# Access Compliance Report

## Public Rights-of-Way

Intersection ID: 51519	Main Street: E JOHN BELK RA	Cross Street: SOUTH BV	Location: SW
ADA ID: B0A54C5D5BA8	Ramp Type: Perp	Initial Pass/Fail: Fail	Overall Compliance: No
			Severity Score: 8.75

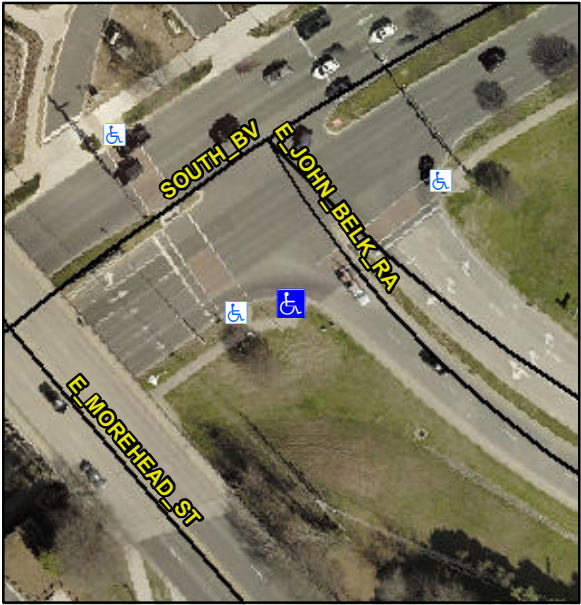
Codes/Mitigation Info/Possible Solution		Field Measurements/Component Compliance			
	Possible Solutions:				
	Remove & Replace Entire Ramp.				
<p>Surveyor Notes:</p> <p>N/A</p> <p>PROW/ADA:</p> <p>R304.5.1</p>					
<p>Street 1 Name</p> <p>Stop Condition-Street 2</p> <p>Street 2 Name</p> <p>Stop Condition-Street 1</p>	E JOHN BELK RA				
	Signal				
	N/A				
	N/A				
<p>Total Cost:</p> <p>\$ 1850.00</p>

Compliance	Description	Data	Compliance	Description	Data
N/A	Ramp Length (in)	160.0	Yes	Ramp Slope (%)	5.7
No	Ramp Width (in)	47.0	Yes	Ramp XSlope (%)	0.9
N/A	Flare Type LT	N/A	N/A	Flare Type RT	N/A
N/A	Flare Slope LT (%)	N/A	N/A	Flare Slope RT (%)	N/A
N/A	Flare Traversable LT?	N/A	N/A	Flare Traversable RT?	N/A
N/A	Landing Length (in)	N/A	N/A	DWS Provided?	N/A
N/A	Landing Width (in)	N/A	N/A	DWS Contrast?	N/A
N/A	Landing Slope (%)	N/A	N/A	DWS Length (in)	N/A
N/A	Landing X Slope (%)	N/A	N/A	DWS Full Width?	N/A
N/A	Landing Curb? (Y/N)	N/A	N/A	DWS Offset (in)	N/A
N/A	Shared Landing?	N/A			
N/A	Gutter Ponding?	N/A	N/A	Gutter Slope (%)	N/A
N/A	Gutter Lip Ht (in)	N/A	N/A	Gutter X Slope (%)	N/A
N/A	Painted X Walk1?	Yes	N/A	Painted X Walk2?	N/A
	X Walk 1 Direction	To NE		X Walk 2 Direction	N/A
N/A	X Walk 1 Width (in)	133.0	N/A	X Walk 2 Width (in)	N/A
	X Walk 1 Slope (%)	4.2		X Walk 2 Slope (%)	N/A
	X Walk 1 X Slope (%)	5.9		X Walk 2 X Slope (%)	N/A
